# Hanford Site - Richland, Washington Waste Treatment and Immobilization Plant (WTP)

## INDEPENDENT REVIEW OF WTP ESTIMATE AT COMPLETION (EAC) 2005

U.S. Department of Energy

U.S. Army Corps  
of Engineers®  
Cost Engineering Directory of Expertise for  
Civil Works and International / Interagency Support  
Walla Walla District

**Figure 3-1 Horizontal Design Response Spectrum**

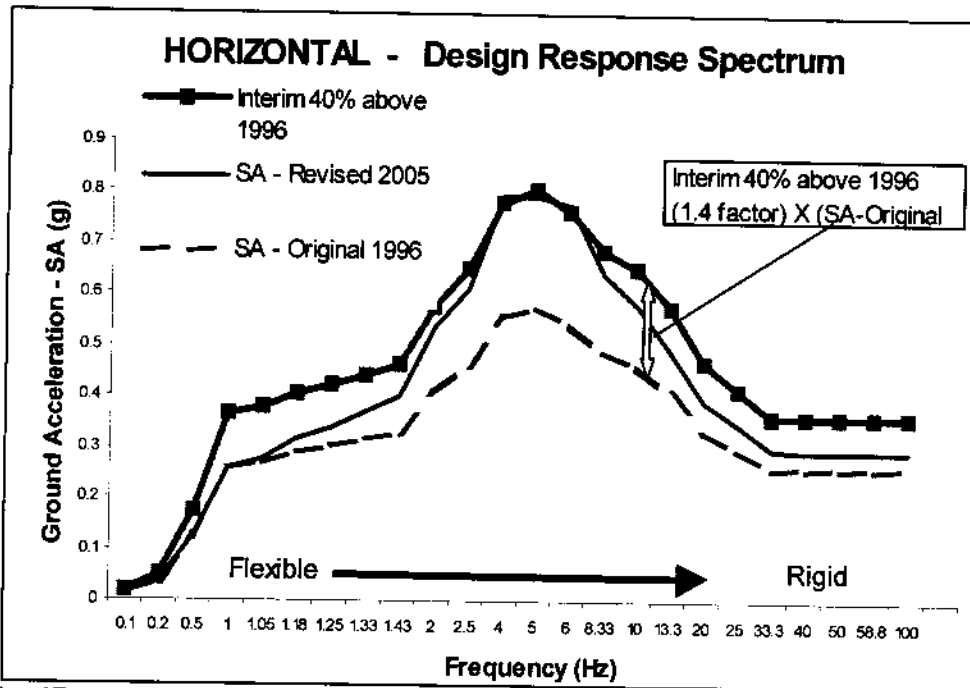
Figure 3-1 shows that the difference between the revised ground spectra (2005) can be significantly less than the 40 percent interim criteria. Verbal presentations indicated that many of the tanks, vessels, ductwork, and other features were designed to be relatively rigid, having higher frequency values. For rigid structures, systems, or components, the amplification would likely be much less than the 40-percent interim criteria.

Figure A-2 Seismic Analysis and Design Schedule Tasks

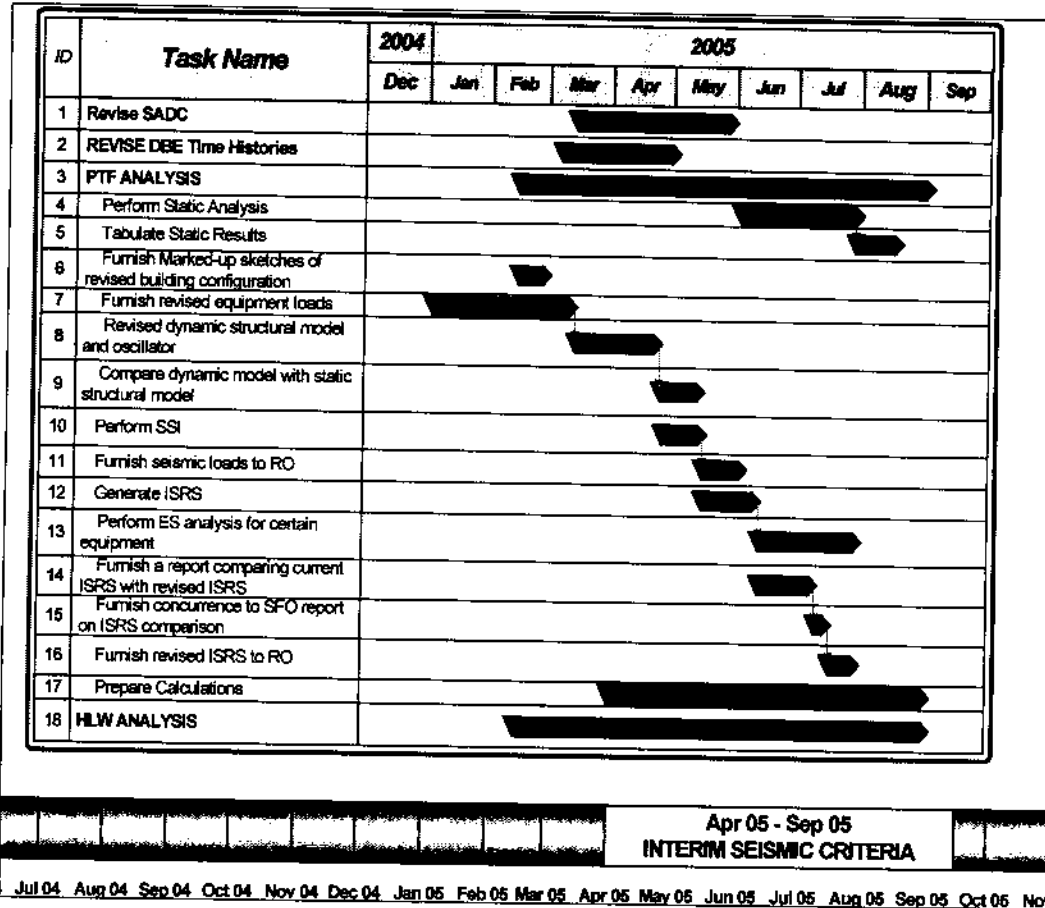
The tentative schedule for the revisions to the calculations was reviewed and compared to the timeframe established for the interim seismic criteria. This data was taken from the Waste Treatment Project Revised Ground Motion Preliminary schedule, but not all associated subtasks are shown. The scheduled completion and the status of BNI meeting that schedule was confirmed during a number of meetings. The preliminary schedule supports the DOE-ORP decision to only allow the use of the interim seismic criteria through mid- September 2005. This information tentative completion was validated during a number of briefings. This is shown in figure A-2.

Figure A-3 Medium Pressure Vessel Schedule Impacts

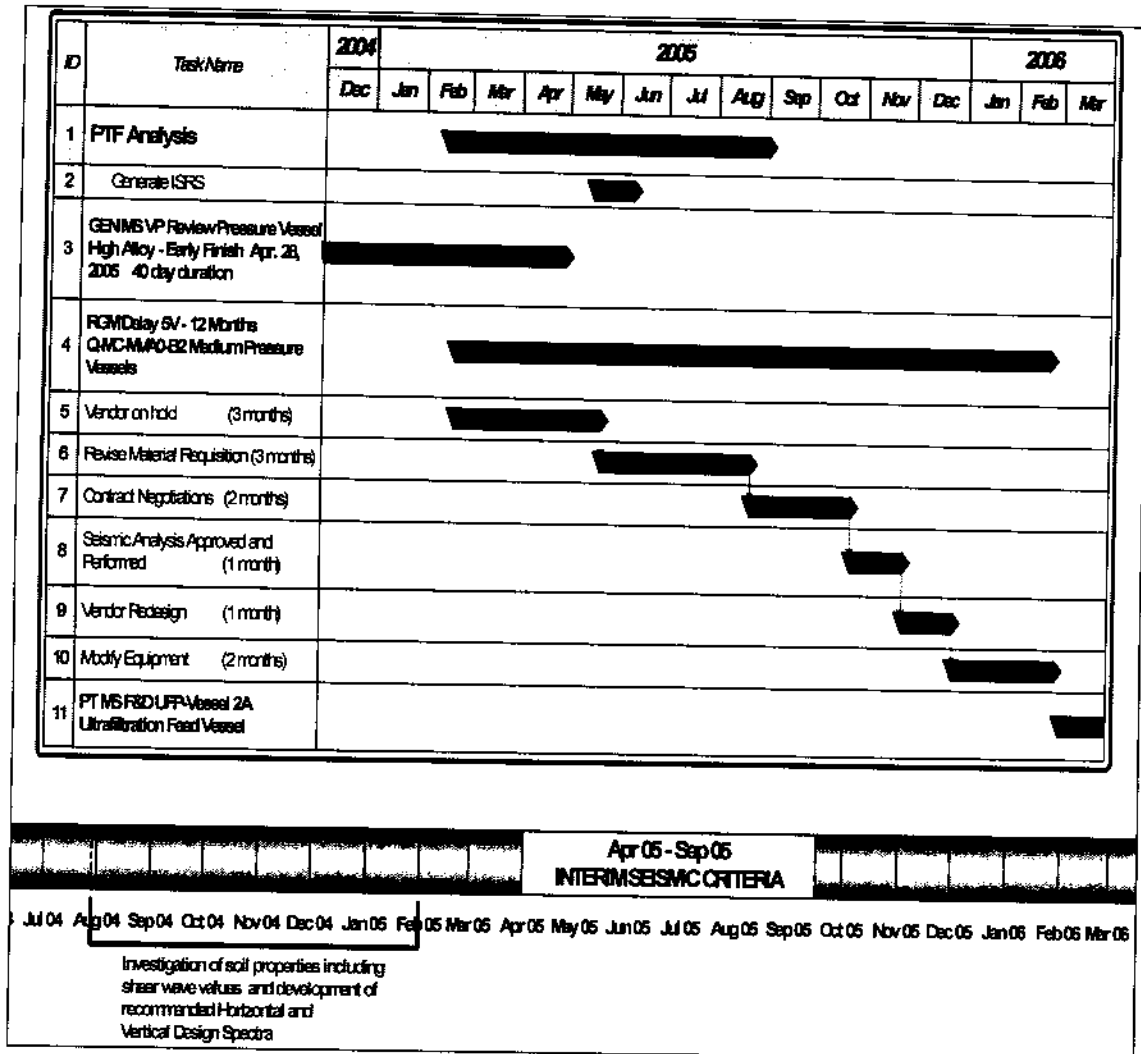
With the information available at this time, there is no basis for assessing the appropriate time frame for the overall, 12-month delay. The overall time frame established for the identified vessel may be reasonable, but there is no back up or

documentation to support the distribution, the increases in the scheduled time for the vessel procurement, and the fact that the activities are established as sequential without overlap. In addition, the actual increase in the seismic demand on the component and the specific impact is not yet clear. Typically, in the schedule there is no explanation or justification for the establishing the activities as sequential and not overlapping activities. In addition, there is no clear indication of why the schedule should include over two months to revise the Material Requisitions after the scheduled completion of the revised in-structure response spectra (See figure A-3).
